SUPPLEMENTAL INSTRUCTION

PROJ.: **Boys and Girls Club Prince of Wales**
PROJ. No.: **1716**
DATE: **April 18, 2018**
S.I. No. **S.I. - 024**

Revised Electrical to Universal Toilet Room Layout

DRAWING ECCN-02 REVISED UNIVERSAL WASHROOM

UNIVERSAL WASHRM LIGHTING

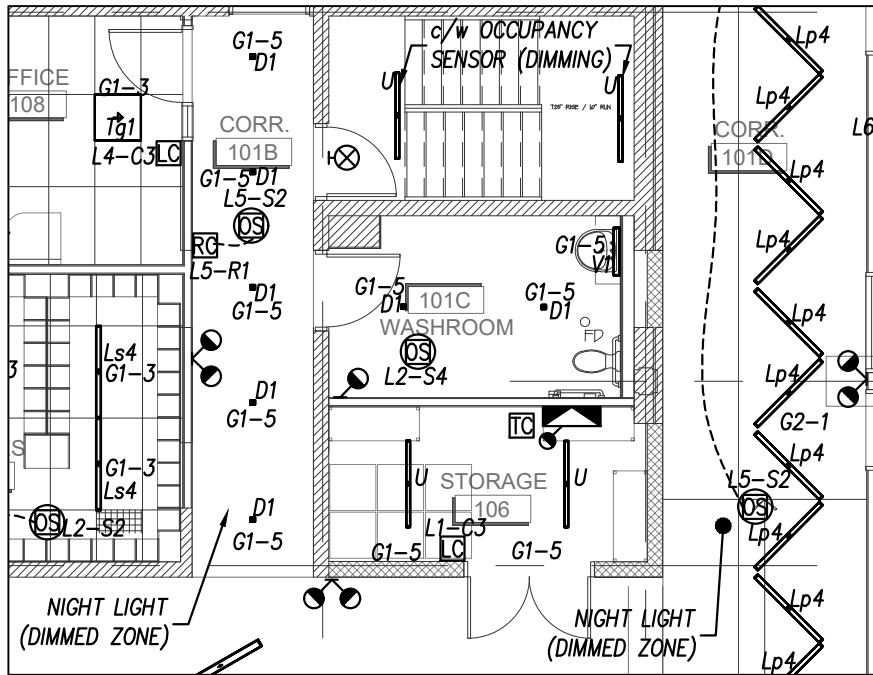
Issued to coordinate electrical with revised universal washroom architectural revision.

- 1.□ See ESK-3
 - a.□ Revise electrical & lighting device locations to accommodate revised universal washroom layout.

UNIVERSAL WASHRM POWER & SYSTEMS

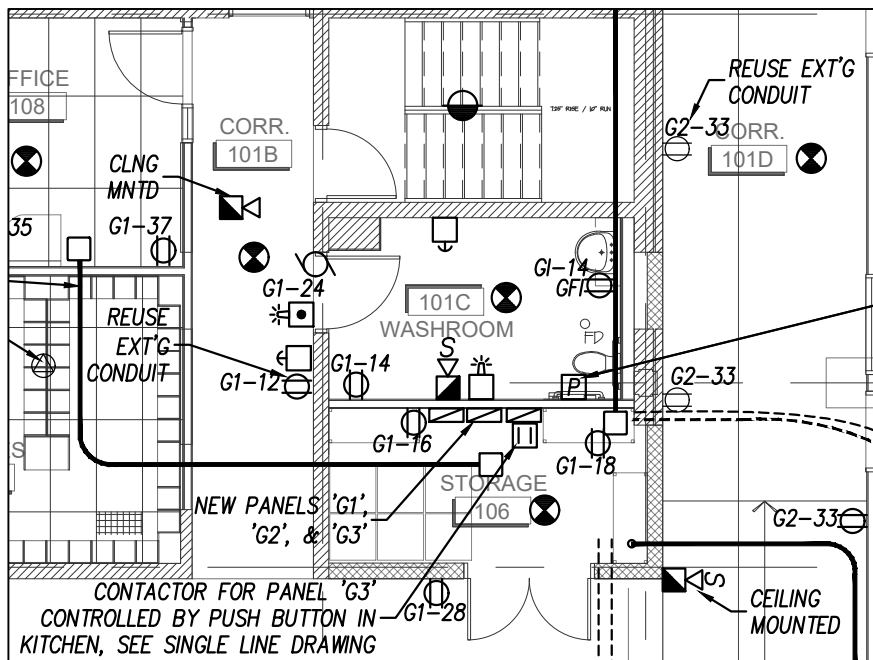
UNIVERSAL W/R 101C - EMERGENCY CALL BUTTON MOUNTED AT 950mm AFF WITH SIGN ABOVE READING "IN THE EVENT OF AN EMERGENCY PUSH EMERGENCY BUTTON AND AUDIBLE VISUAL SIGNAL WILL ACTIVATE" - PROVIDE TRANSFORMER AND RECTIFIER IN CEILING ABOVE AND TWO AUDIBLE & VISIBLE SIGNAL DEVICES AS SHOWN - CONNECT ON G1-45

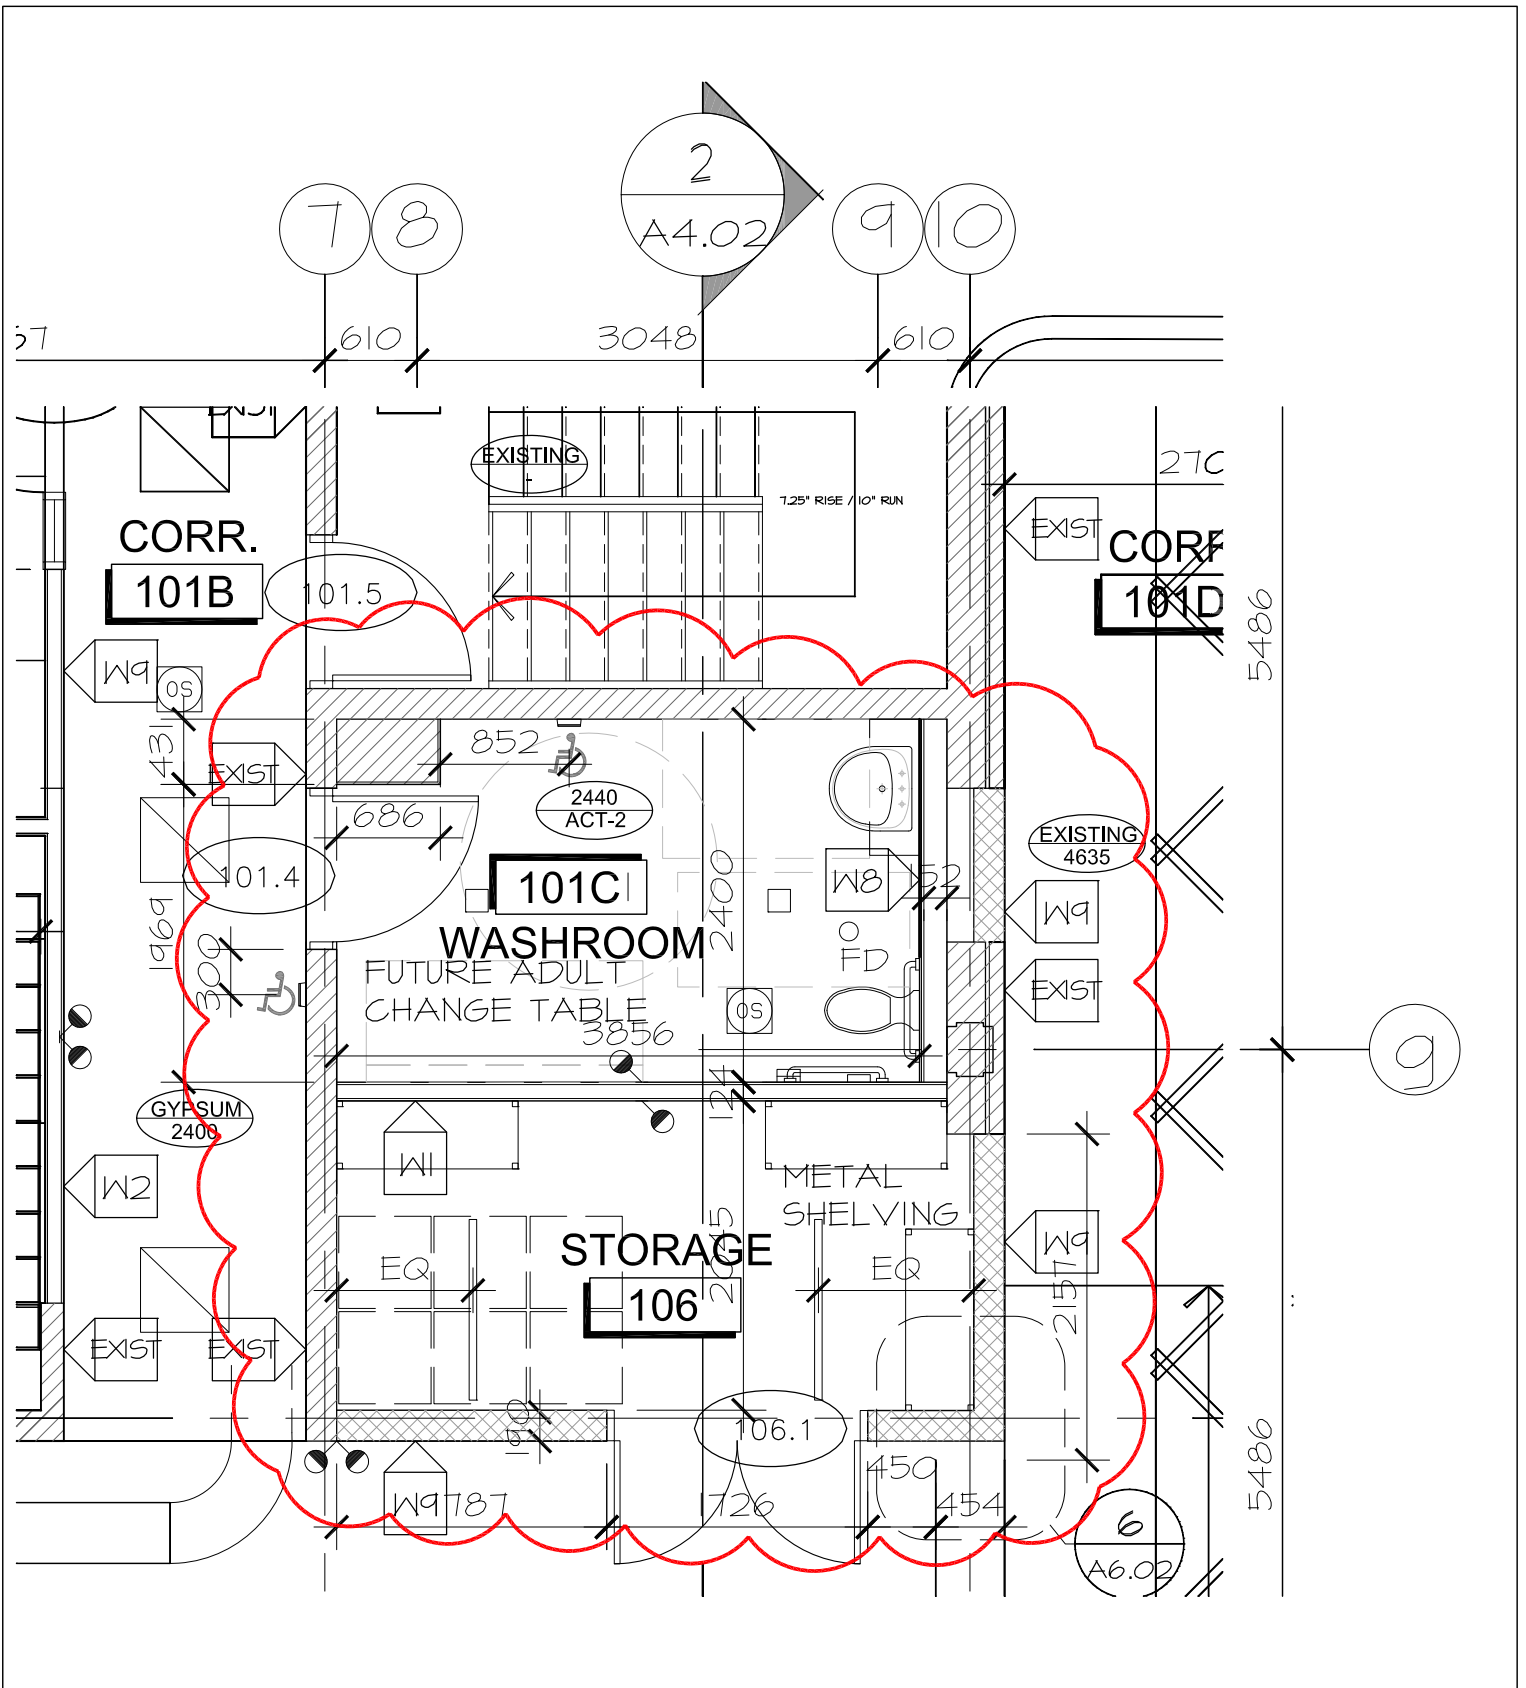
.1 Revise Universal Washroom Layout as per revised attached ASK-006

To accommodate existing mechanical duct riser and existing door opening.
